**OPEN SPACE ADVISORY COMMITTEE
STAFF REPORT**

REQUEST: For discussion only on the wetlands enhancement project at the old Buzzy's Ranch property

Buzzy's Ranch Wet Meadow Pasture Improvement Plan Status

Remaining project components for which engineering design work is in progress/nearly complete or for which updates/additions to the plan set are needed are (reference the preliminary plan set dated 11/5/2015):

PROJECT NO. US-NV-33-7	DATE: 11/5/2015	DESIGNED BY: JR
BUZZY'S RANCH PROJECT		
WETLAND RESTORATION / ENHANCEMENT		
DRAWN BY: JM	CHECKED BY: JM	SHEET NO. 4 of 6
SITE PLAN

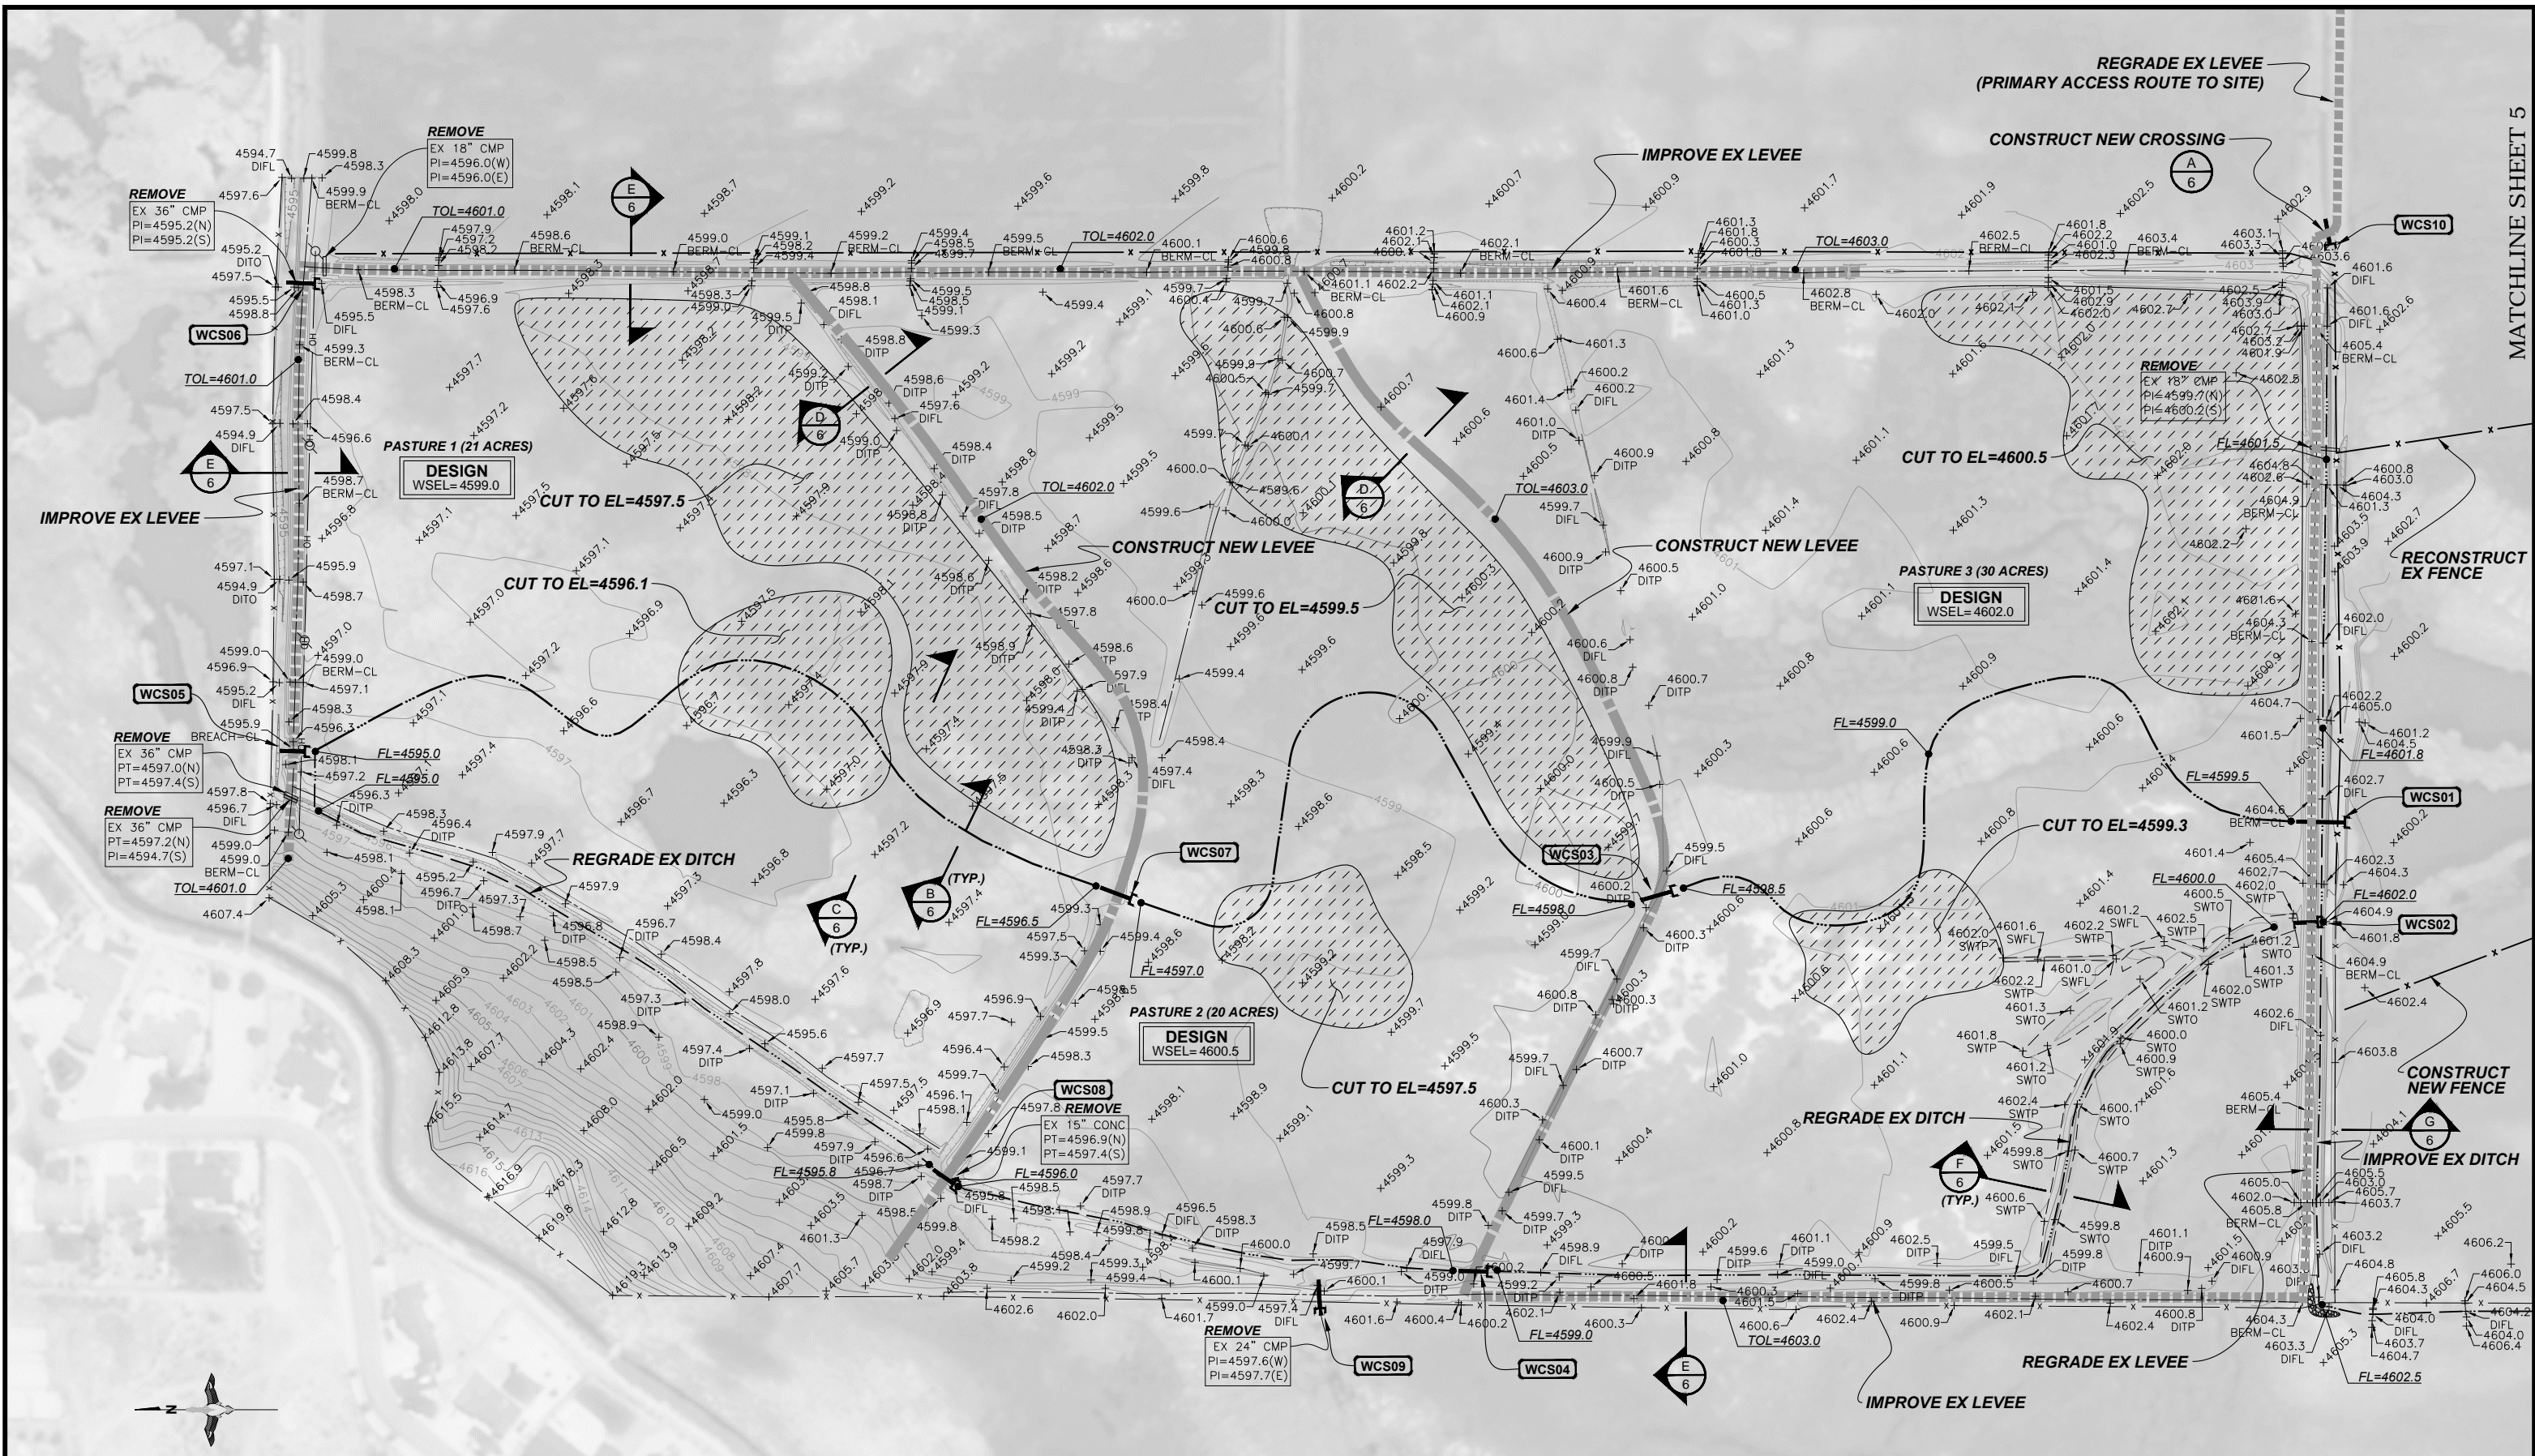
Sheet 4:

- Water Control Structure (WCS) #1 cross-section detail that is shown in Section H on the detail sheet (Plan Sheet 6) needs to be finalized.
- Engineering design work for entry access road from Mickey's corral area to the project site needs to be completed. The route is depicted on Sheet 3, and a portion is included on Sheet 4; the remaining portion to be included on Sheet 5 or a new sheet.
- Hatch patterns for pothole borrow to be differentiated from other borrow areas within the 3 proposed pastures.
- Entry gate / access point(s) will be added to the site plan.

D TYPICAL SECTION NEW LEVEE
NOT TO SCALE

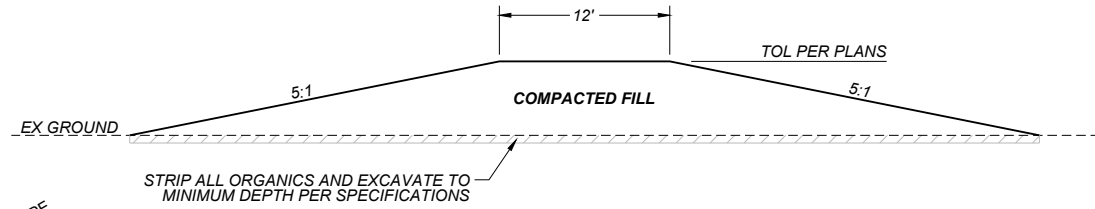
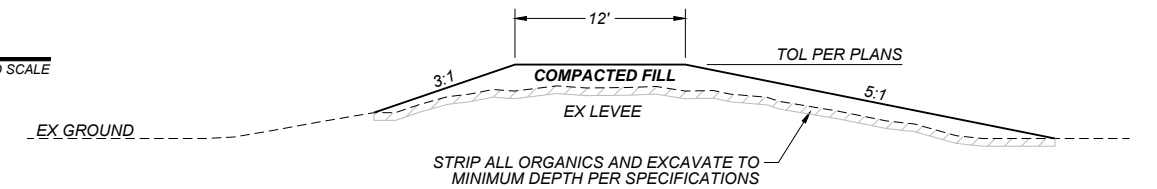
Sheet 6:

- Several design details are to be revised and/or added. For example, Cross-Section detail H for water control structure #1 (see Sheet 4 for location) needs to be finalized.
- Sections D & E show proposed new and improved levees with top widths of 12 feet. These will be revised to be 8- to 10-foot wide per as discussed at our field meeting on October 22.
- Details about Water Control Structures and pipe will be added into the WCS table on Sheet 6. For example, this will include rip-rap quantity, aggregate base quantity, structure type (tailwall or twin track weir).
